PLANT NAME: Oconee, Units 1-2-3

Re: Oconee Nuclear Station
Docket Nos. 50-269, -270, -287

SUPPLEMENT 1
TO
MDS REPORT NO. OS-73.2
ANALYSIS OF EFFECTS RESULTING FROM
POSTULATED PIPING BREAKS OUTSIDE CONTAINMENT
FOR
OCONEE NUCLEAR STATION, UNITS 1, 2, AND 3

The following information is voluntarily submitted in response to informal questions asked by the Division of Reactor Licensing during the June 12, 1973 meeting held in Bethesda, Maryland.

OCONEE NUCLEAR STATION
 MAIN STEAM SYSTEM
 LINE INTERACTION RESTRAINT
 (PRELIMINARY)
 FIGURE 4.2-1.b₂

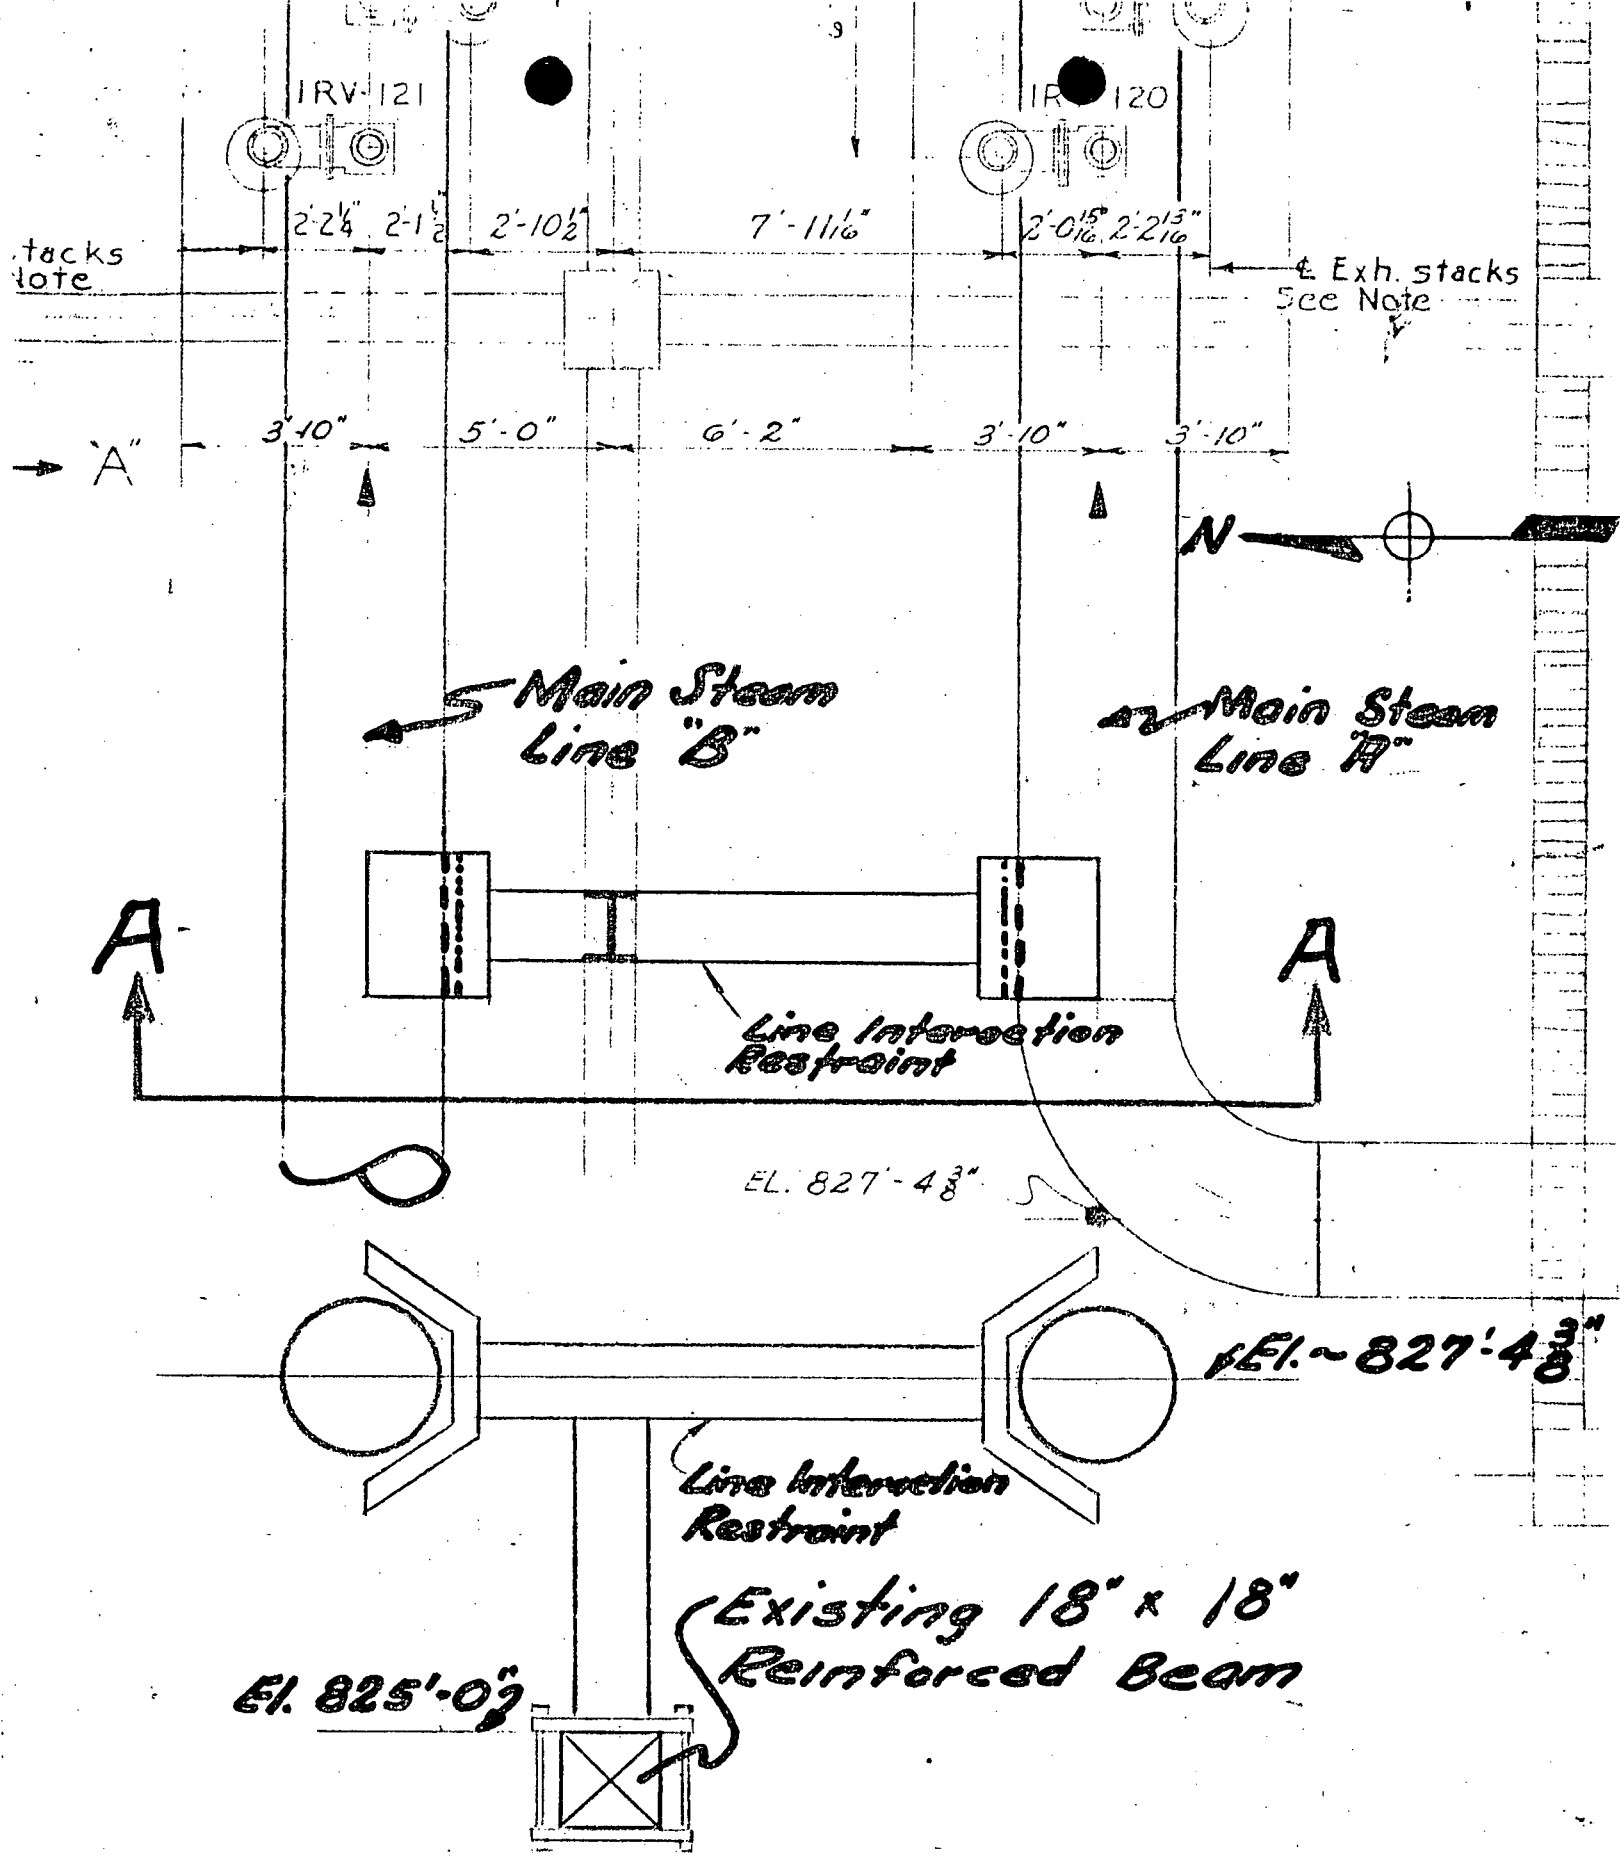
Describe the existing restraint system for the Main Steam lines and any proposed modifications.

Proposed modifications are to add a line interaction restraint between the two Main Steam lines immediately upstream of the Main Steam safety valves for the purpose of preventing a line break in Main Steam line B as a result of Main Steam line A terminal end break. The restraint will be designed to the following criteria:

1. Prevent Main Steam line A from interacting with Main Steam line B safety valves.
2. Normal thermal movements of either Main Steam line are not to be impaired
3. Mechanical loading and stress analysis aspects are:
 - a) All load bearing members will be designed to 0.9 yield stress for primary stresses.
 - b) A dynamic load factor of 3.0 will be used for applicable load bearing members of the restraint.

Figure 4.2-1.b₃ is a preliminary conceptual design of the proposed restraint.
